# UNITED STATES PATENT AND TRADEMARK OFFICE

APPLICATION NO.	FILING DATE	FIRST NAMED INVENTOR	ATTORNEY DOCKET NO.	CONFIRMATION NO.
10/501,237	07/12/2004	Stephane Phelep	0510-1100	5317

<b>Office Action Summary</b>	<b>Application No.</b> 10/501,237	<b>Applicant(s)</b> PHELEP ET AL.	
	<b>Examiner</b> James S. Bergin	<b>Art Unit</b> 3641

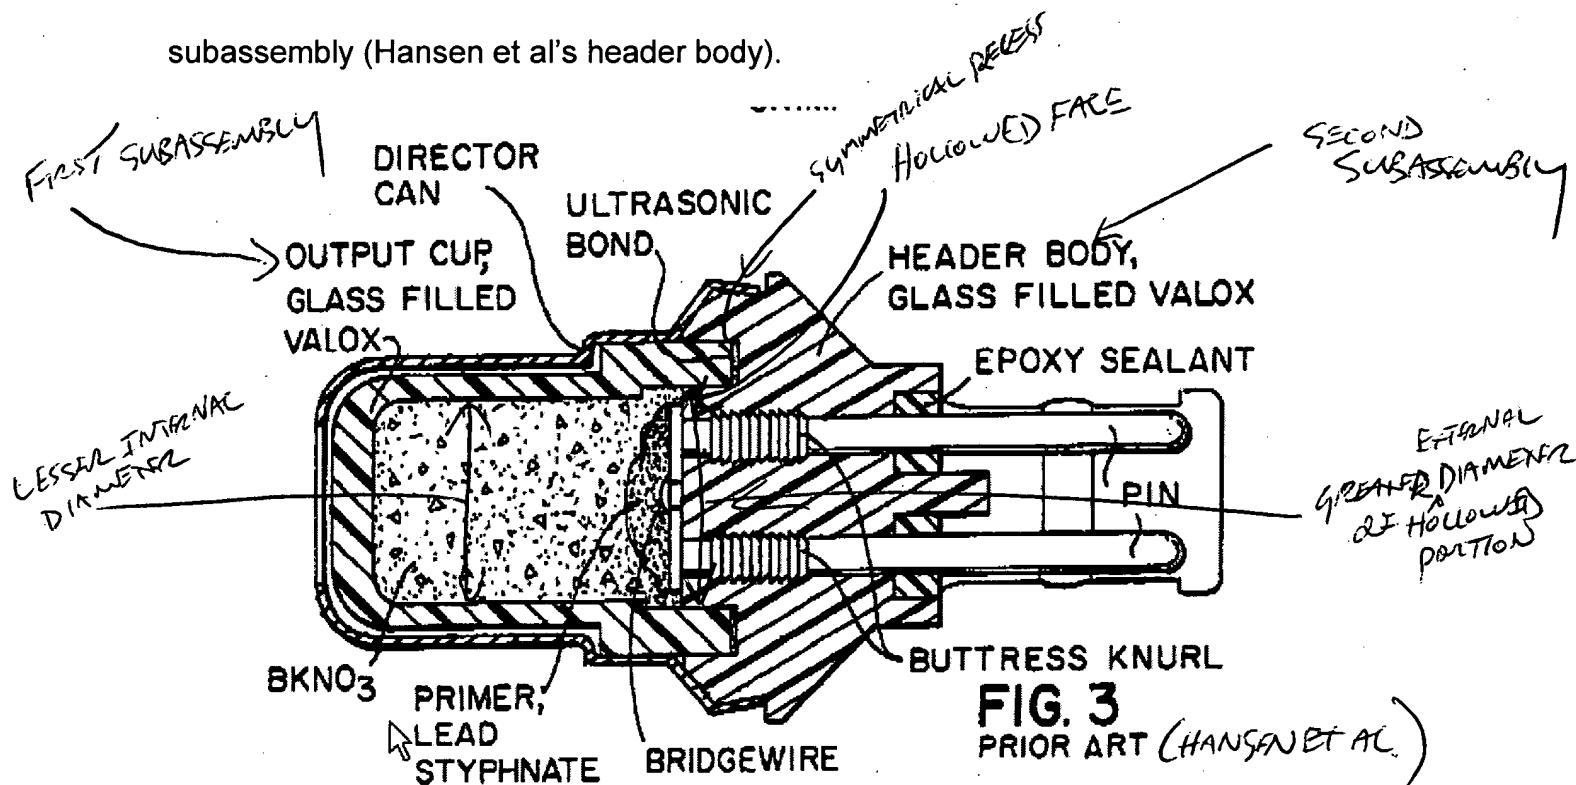
Regarding claims 2 and 11, see the marked up copy of Hansen et al's Fig. 3.

Regarding claim 9 and 10, Hansen et al's pins comprise electrodes that are scored (buttress knurl - fig. 3 above).
